**BEFORE THE HEARINGS PANEL  
FOR THE PROPOSED QUEENSTOWN LAKES DISTRICT PLAN**

**IN THE MATTER** of Hearing Stream 14:  
Wakatipu Basin hearing  
and transferred Stage 1  
submissions related to  
Arrowtown and Lake  
Hayes

**SUPPLEMENTARY STATEMENT OF EVIDENCE OF BRIDGET MARY GILBERT  
ON BEHALF OF QUEENSTOWN LAKES DISTRICT COUNCIL**

**Primary submitters:**  
Spruce Grove Trust (2214)  
Boxer Hill Trust (2386)  
Banco Trustees (2400)

Figure 2: Proposed MRZ on the submitter's land (sourced from submission). Green area corresponds to the submitter's proposed Golf Course and Open Space area. Brown toned area relates to the submitter's proposed Residential activity area (R20). Knoll landform depicted by orange contours.

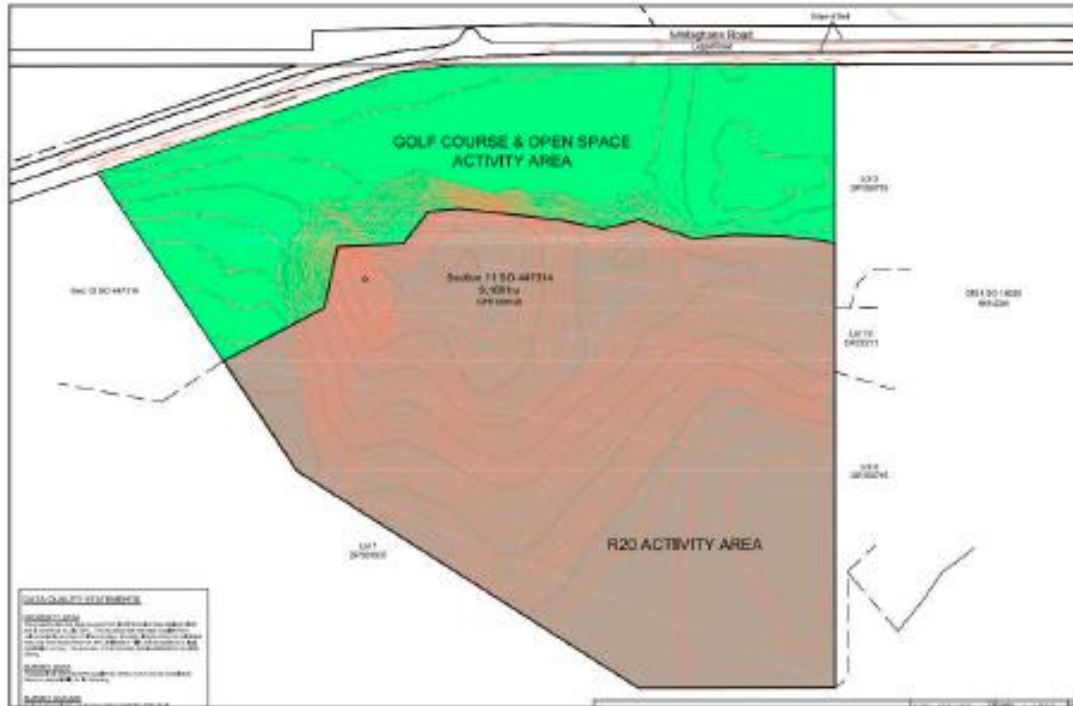
- 2.9** However, in my opinion, any such development should be confined to the flat land on the south side of the knoll landform for it to be acceptable from a landscape perspective.

- 2.10** I note that the extent of R20 proposed in the submission anticipates urban residential development over the crest, west and south sides of the knoll landform. I consider that such an outcome would generate significant adverse land and visual effects in relation to the Millbrook catchment extending from the west around to the south east.

- 2.11** I defer to Mr Langman with respect to the planning merits of including this area within the MRZ.
- 2.12** For these reasons, I do not oppose the application of MRZ to the land addressed Spruce Grove Trust submission, subject to its confinement to the flat land on the south side of the knoll landform on the property.

Figure 4: Approved 4 Lot Subdivision Structure Planting Plan (sourced from Environment Court decision).

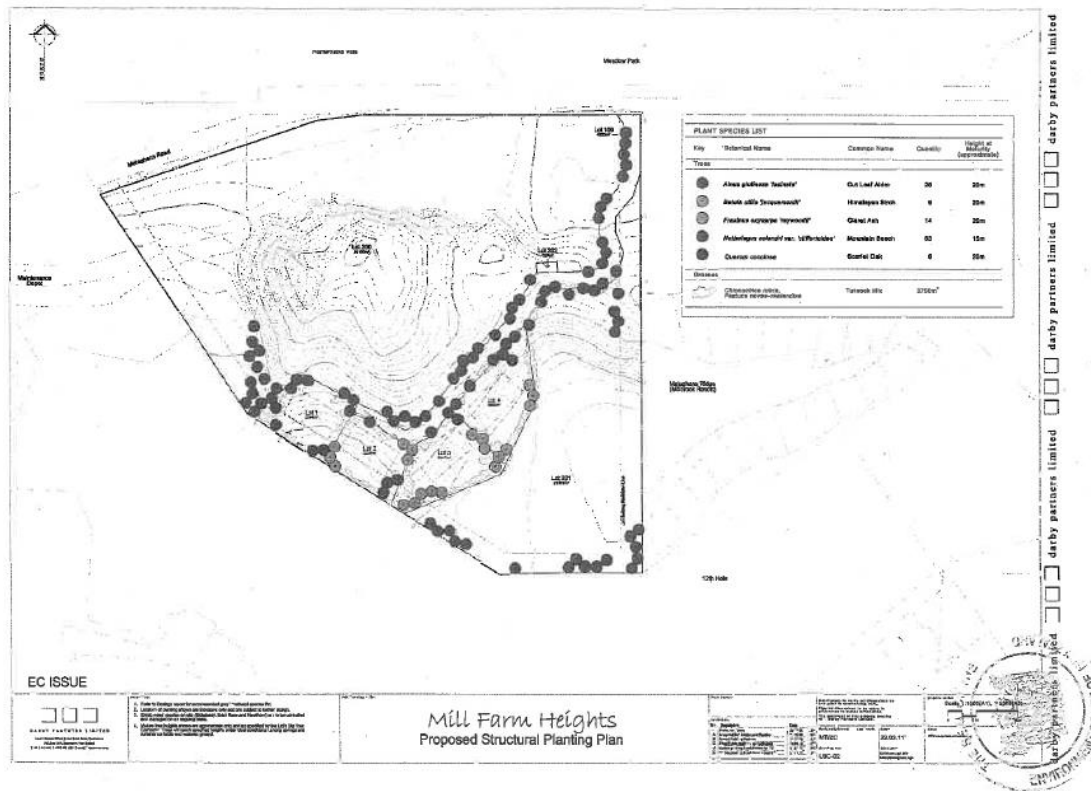
2.7 As the submission explains, a four-lot subdivision has been approved on the property with lots ranging in size from 2,258m<sup>2</sup> to 2,980m<sup>2</sup>. The four building platforms are located on the south side of the knoll. It is my understanding that mitigation planting together with the knoll landform are intended to screen the approved development from Malaghans Road. A series of poor quality graphics showing the general layout of the approved subdivision are reproduced from the Environment Court decision<sup>1</sup> below.

- 2.8** In my opinion, the approved (by consent) rural residential development on the southern portion of the submitter's land, together with its visually discreet character, and close proximity and visual connection with the neighbouring residential development at Millbrook, suggests that this part of the property could be developed as MRZ without compromising the landscape character and visual amenity values of the wider Basin.
